Subject: Byron Station Units 1 and 2
Braidwood Station Units 1 and 2
Pipe Support Anchor Plates
NRC Docket Nos. 50-454, 50-455,
50-456, and 50-457

This is to provide additional information regarding the flexibility of baseplates for pipe supports at Byron and Braidwood. NRC review of this information should close Outstanding Item 5 of the Byron SER.

ADDITIONAL INFORMATION REQUESTED ON RESPONSE
TO NRC QUESTIONS 110.71 AND 110.72

Figure 3
IDEALIZED LOAD-DISPLACEMENT CURVE FOR 1/2" DIAMETER
EXPANSION ANCHORS

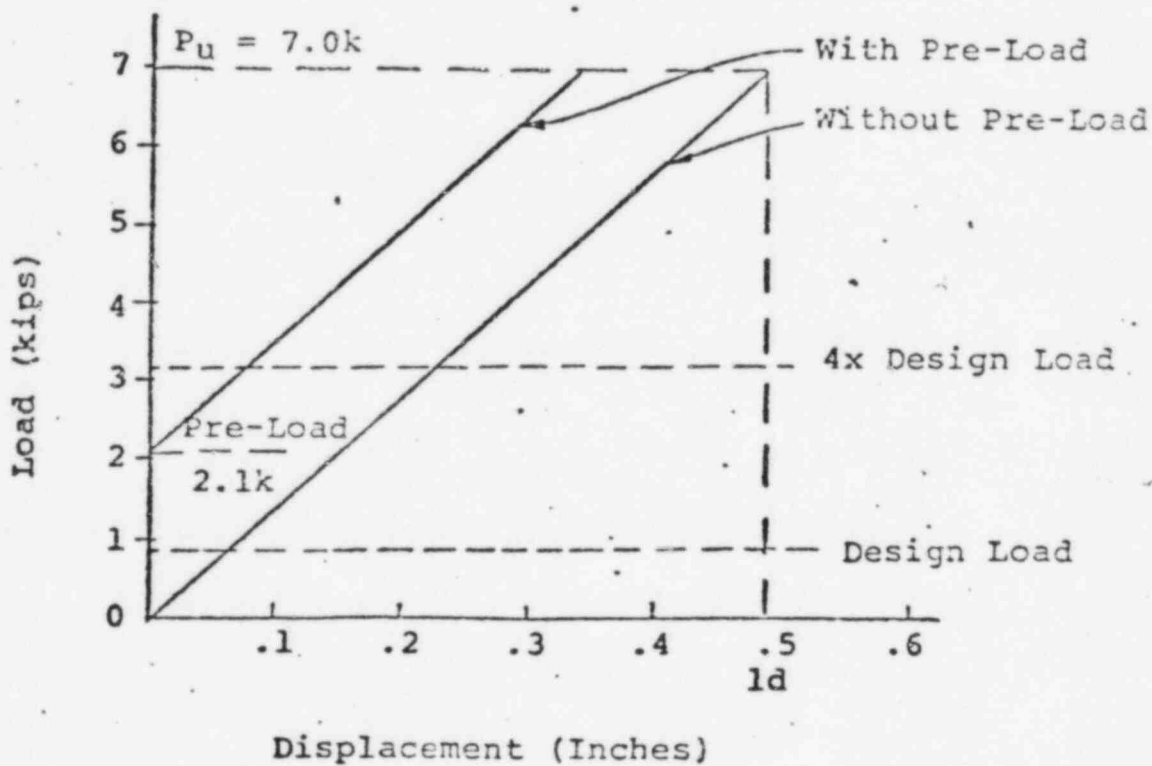
The response to FSAR question 110.71 which was transmitted in reference (b) discussed the amplification factor used in the design of the four-anchor plate. The load-displacement curve used originally in the computation of amplification factor was shown in Figure 3 of reference (c) and is enclosed with this letter. The four anchor plate assembly has been reanalyzed based on a conservative idealization of the load-displacement curve as plotted on the enclosed Figure 2.11. This reanalysis confirmed the 1.0 amplification factor of the four anchor assembly.

FIGURE Q110.72-1

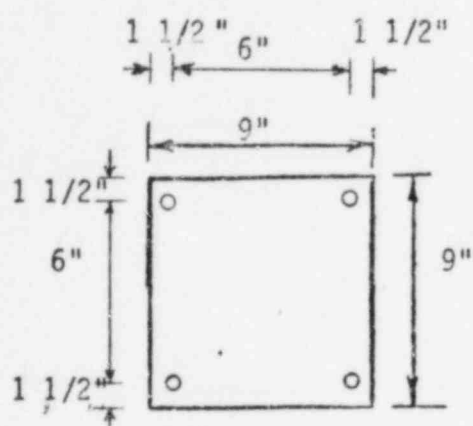
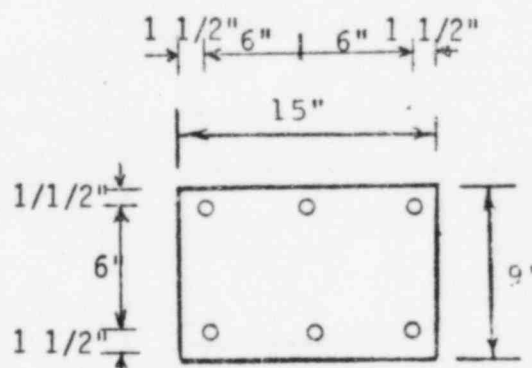
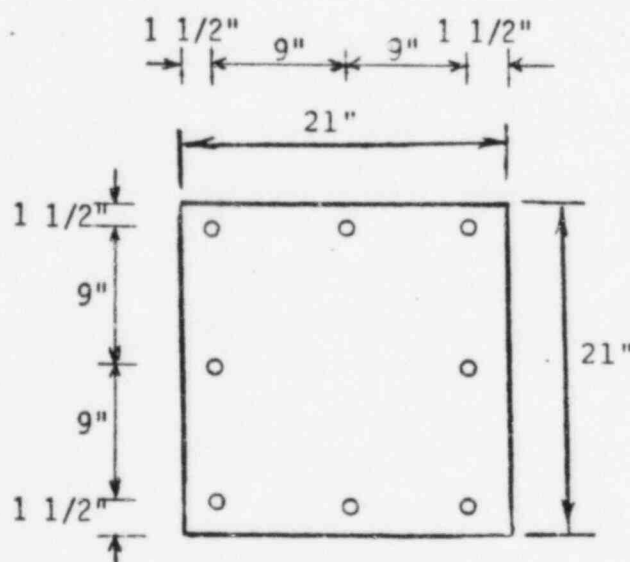
The response to FSAR question 110.72 contained anchor plate descriptive information which did not include edge distances of the anchor bolts. This information has been included on the enclosed revised Figure Q110.72-1.
